WASHINGTON FOREST PROTECTION ASSOCIATION  
724 Columbia St NW, Suite 250  
Olympia, WA 98501  
360-352-1500 Fax: 360-352-4621

**Subject:** Comment Letter on Ecology's Draft Tier II Antidegradation Analysis for Proposed Western Washington Type Np Buffer Rule (July 2025)

Above: Example side by side comparison of buffering strategies of proposed rule on a single real world Np stream. Baseline conditions are in pink (left) and are inclusive of field-verified Np stream segment and applicable unstable slope protections in this case.

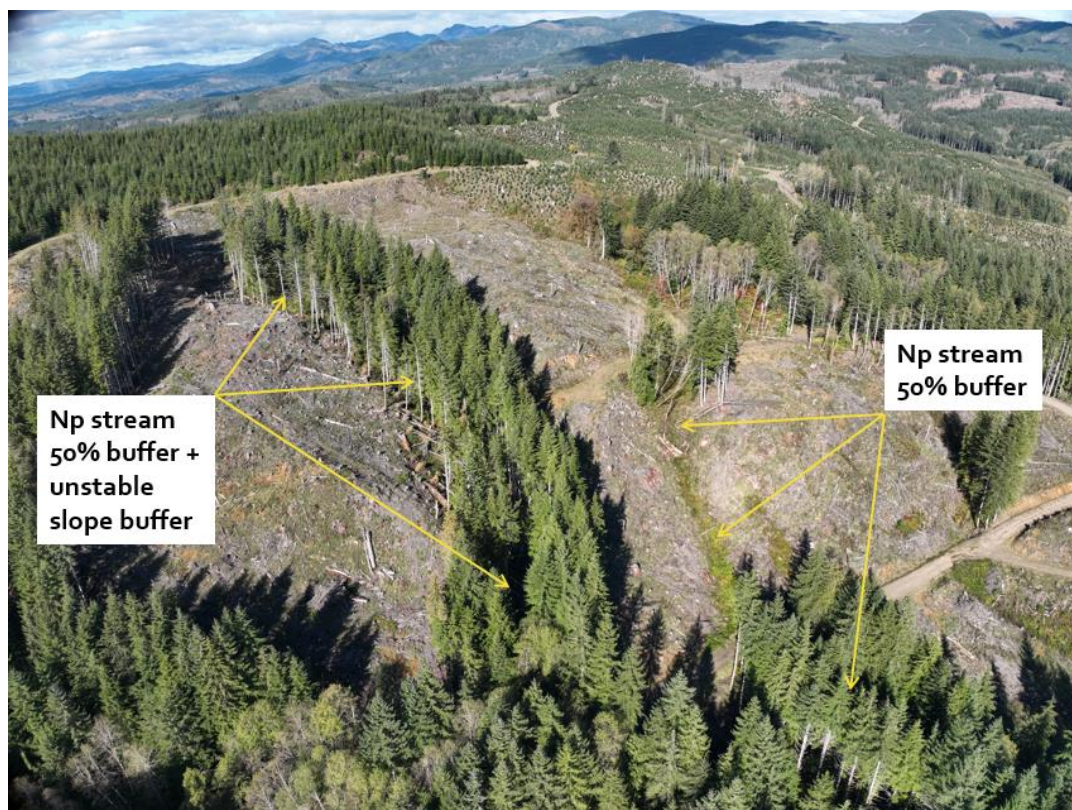
We recommend accounting for baseline conditions by sampling statistically meaningful real-world data from approved FPAs for further analysis. A statistically meaningful sample population of real-world timber harvest data by ecoregion will account for all usual reasons Np streams are buffered in the real world.

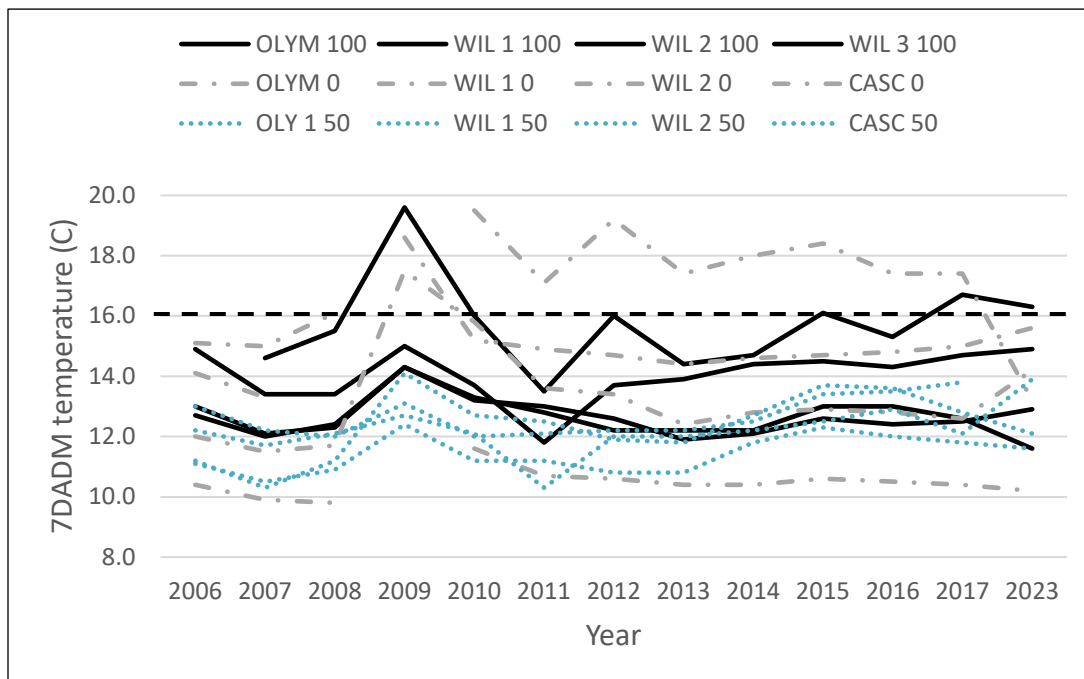
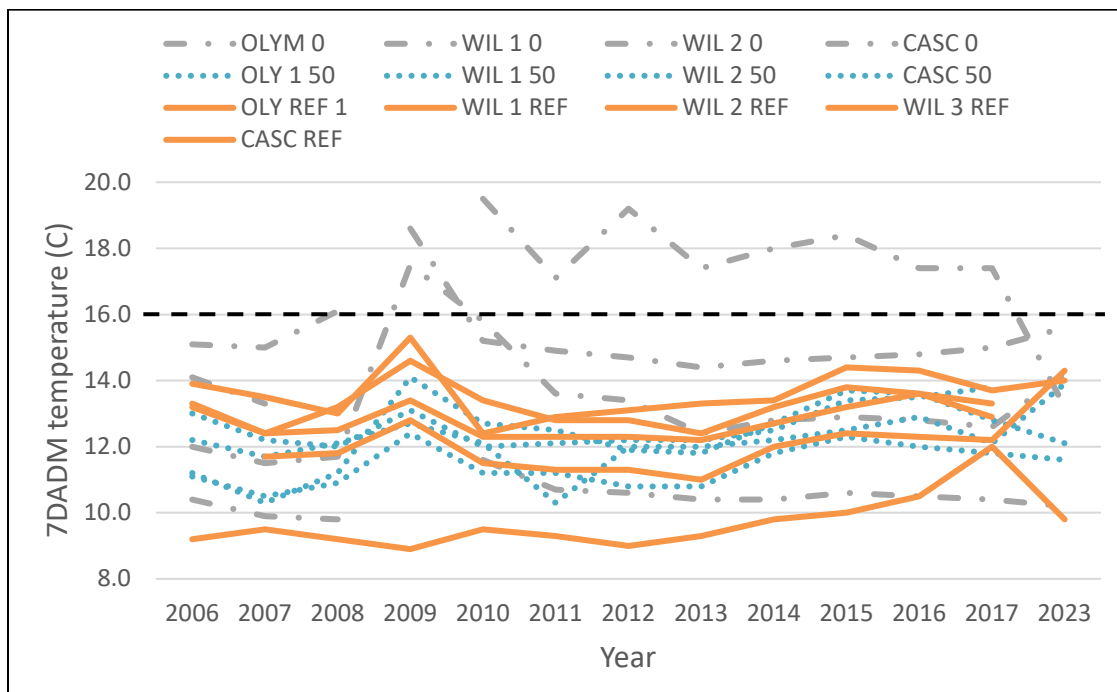
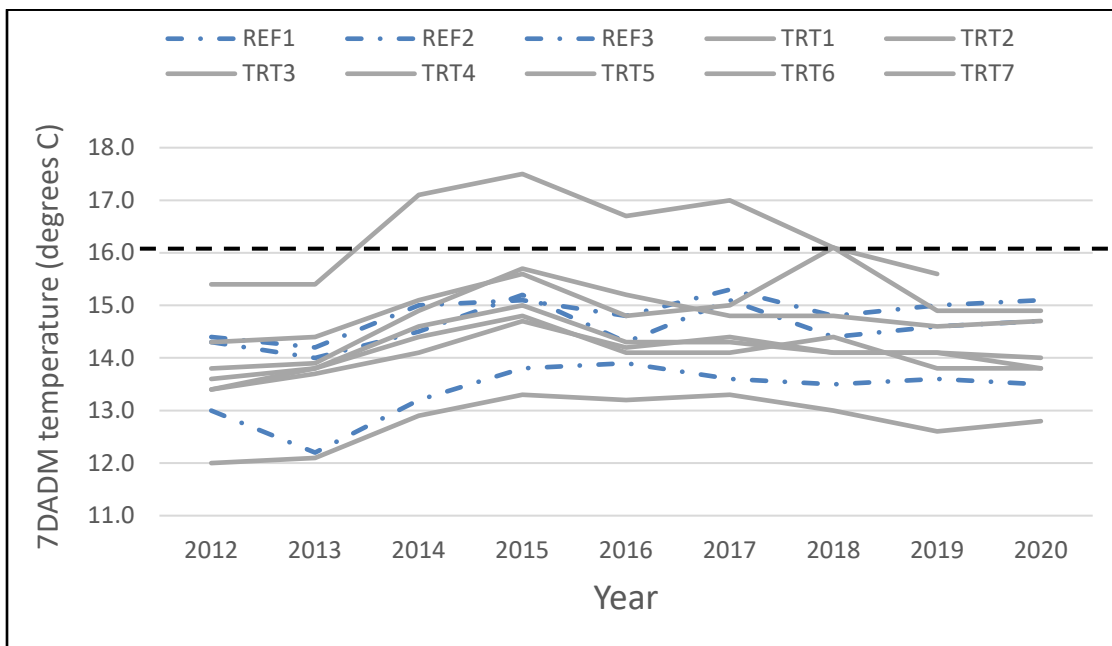
The results from the Soft Rock study showed a similar pattern (Figure 3). Again, the warmest harvest unit was treated (clearcut harvest with a two-sided 50 ft [15.2 m] wide riparian buffer along at least 50% of the perennial stream channel, including buffers prescribed for sensitive sites and unstable slopes). However, the coldest harvest unit across all years of observation was also treated and four of the five coolest harvest units were treated (across all treated sites in the SR study, the buffer area was 18 to 163% greater than a simple 50-ft-wide buffer along 50% of the stream length; p. 2-9, Ehinger et al. 2021).

**Figure 6:** July mean monthly temperature response (MMTR) vs. canopy closure, percent of stream buffered, and total buffer length for the Hard Rock (black) and Soft Rock (red) studies (p. 4-31; Ehinger et al. 2021). Values are from the first-year post-harvest.

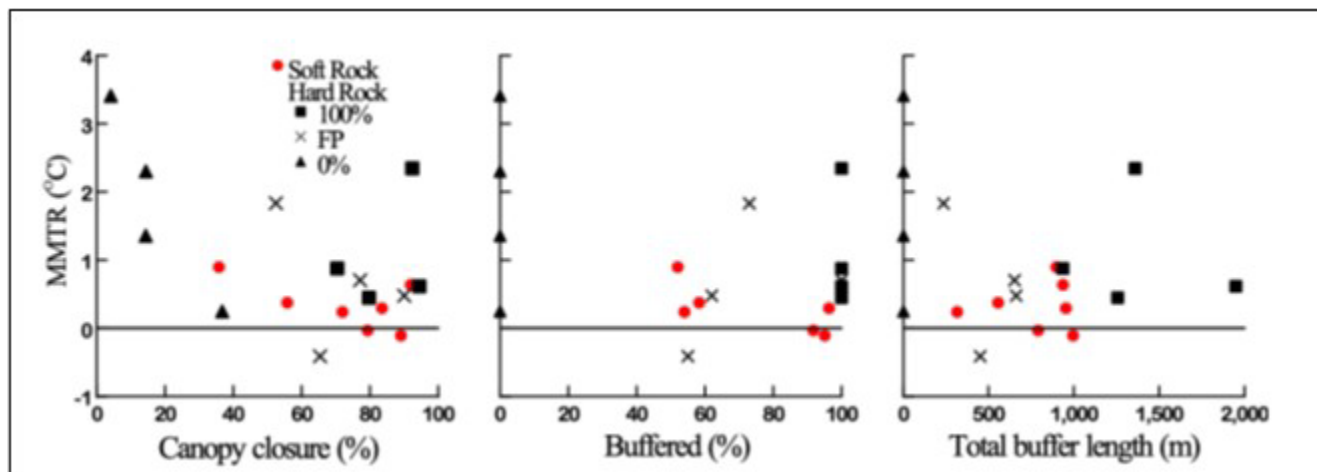
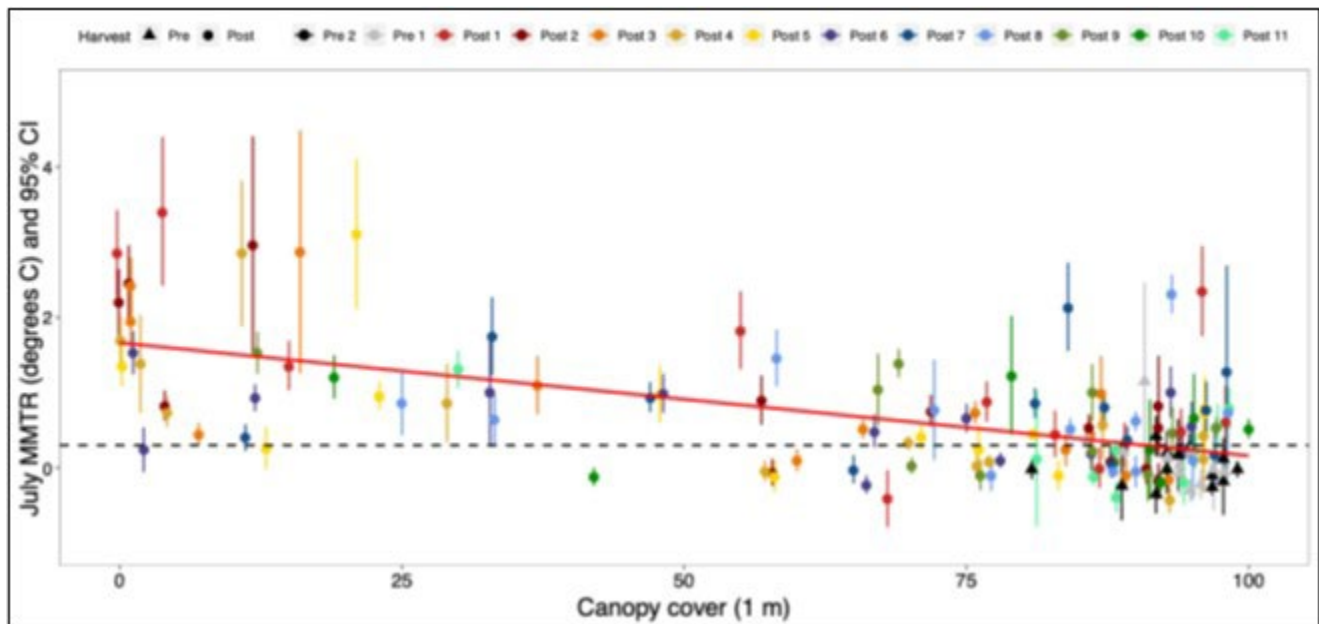
Instead, a purposeful technical synthesis of available information to predict temperature responses as function of buffer characteristics (e.g., extent and/or length) can provide accurate information about temperature responses to management prescriptions. For example, using a statistical model, with appropriate summaries such as 95% prediction intervals (Groom et al. 2018), to understand how out of sample basins would respond to treatments is more reliable than the Tier II approach of narrative associations about locations that may or may not be similar to the populations from which the Hard Rock and Soft Rock studies were selected. At the very least, an attempt to understand how harvest units included in the Groom et al. (2018) analysis compared to harvest units in the Hard Rock and Soft Rock studies, and whether the prediction curve could be applied with or without adjustments to harvest units in Washington, could provide useful context for decision-making (the Type Np workgroup evaluated this option; Barnowe-Meyer et al. 2021). For example, measured buffer widths from the Hard Rock and Soft Rock studies could be used to predict temperatures for reference and treatment units, and these predictions could be compared to the estimated temperatures calculated from empirical data presented in the Hard Rock and Soft Rock final reports.
